Remote Link and System Link February 2012

Version 1.61 Software Update

Effective February 23, 2012, all Remote Link and System Link software is being manufactured as Version 1.61 (2/15/12). This version is an update from the Version 1.61 (12/5/2011) previously shipped and contains new features and updated operation.

Device Setup General Tab

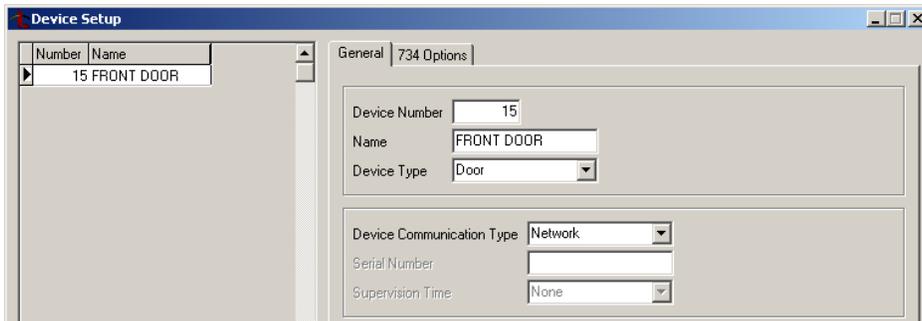
Device Communication Type: For a Device Type of Door, select Keypad Bus to communicate with the device on the keypad bus or select Network to communicate with the device using a network connection. Default is Keypad Bus.

Device Setup 734 Options Tab

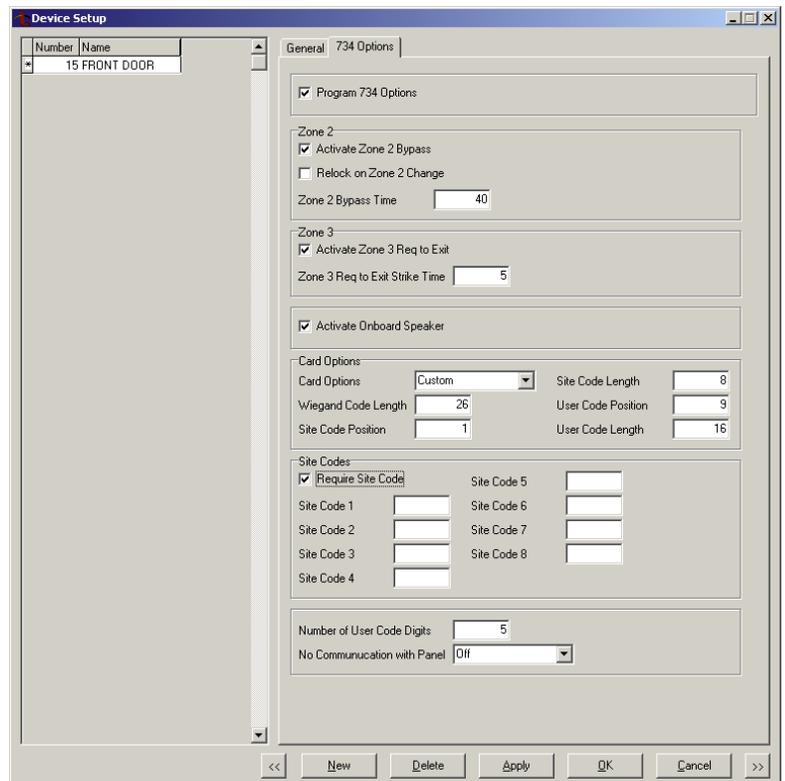
Program 734N Options: Select 734 Options tab to program the 734N Wiegand Interface Module.

Note: Device type on the General Tab must be set to DOOR and Device Communication Type must be set to NETWORK for 734N operation.

Supervisory Alarm Output

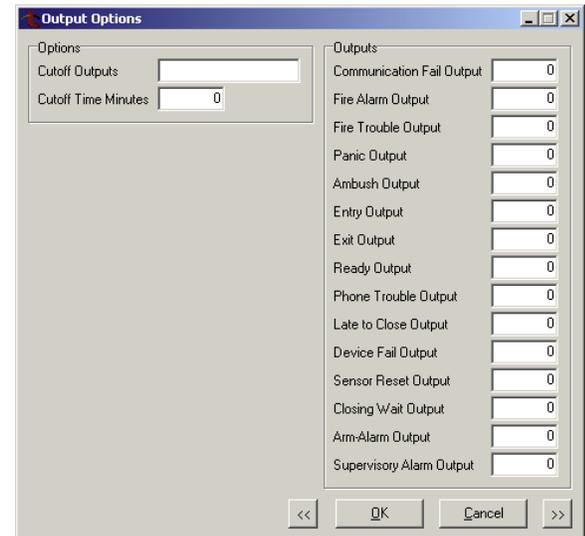
A new output has been added to Output Options to allow the selection of an output for any Supervisory type zone alarms. Previously, the **Fire Trouble Output** turned on when a Supervisory type zone was in an alarm condition.

Supervisory Alarm Output: Enter the output number to turn on when a supervisory zone type is placed into an alarm. The output turns off when all supervisory type zones are restored to normal. Enter 0 (zero) to disable. Default is 0.
